MOSS BROOK ESTATES NORTH SUBDIVISION
PRELIMINARY OVERALL AREA DEVELOPMENT PLAN

Re: Moss Brook Estates North

POADP # 655

The City Staff Development Review Committee has reviewed Moss Brook Estates North Preliminary Overall Area Development Plan # 655. Please find enclosed a signed copy for your files. Although your plan was accepted, please note the following:

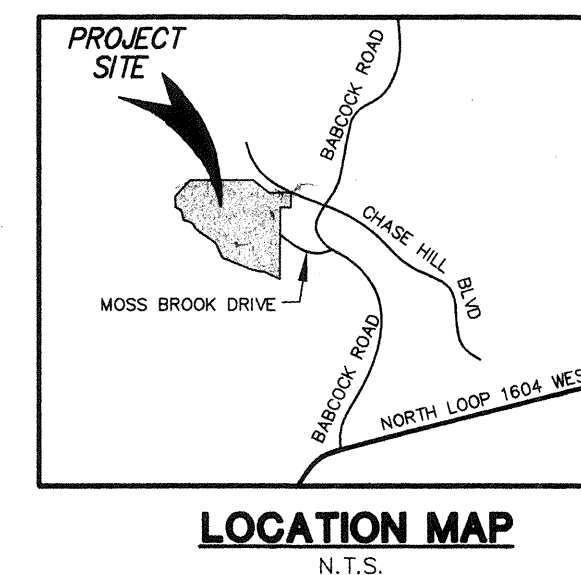
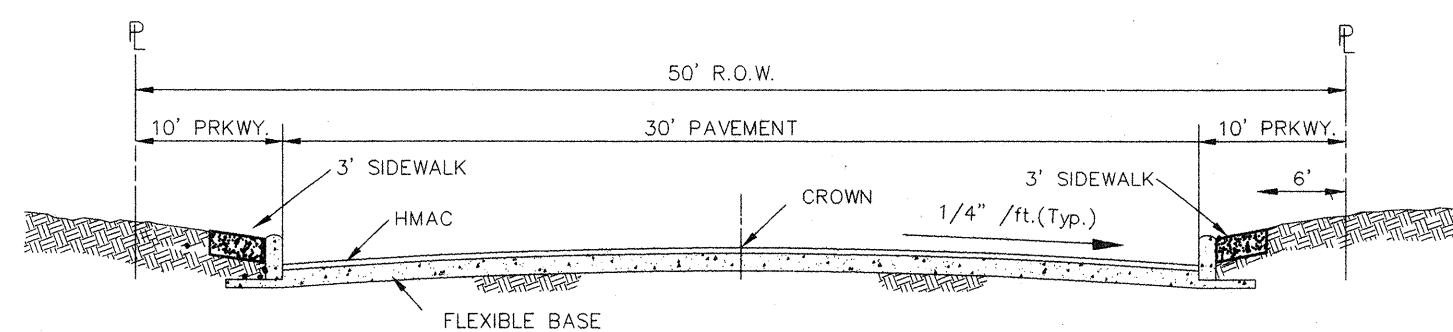
- Based on the topography, a Flood Plain Study and drainage review will probably be required during the platting process. Bexar Co. Public Works will require base flood elevations at the plat level.

- In consideration of public safety and convenience, excessive grades by reason of topography should be avoided in street layouts and arrangements.
- This development will probably need to conform to requirements associated with development over the Edwards Aquifer. For additional information about these requirements you can contact SAWS at 704-7305.

- Access and R.O.W. issues along State facilities will need to be resolved with the Texas Department of Transportation (TXDOT). For information about these requirements you can contact TXDOT at 615-5814.

- This development will need to comply with tree preservation ordinance #85262. For information about these requirements you can contact Building Inspections at 207-7102.

- It will be expected that you will plat all of the property depicted in your POADP, to include: floodpains, drainage areas and open space.
- I would encourage you to work closely with the school district, so that they can plan accordingly.
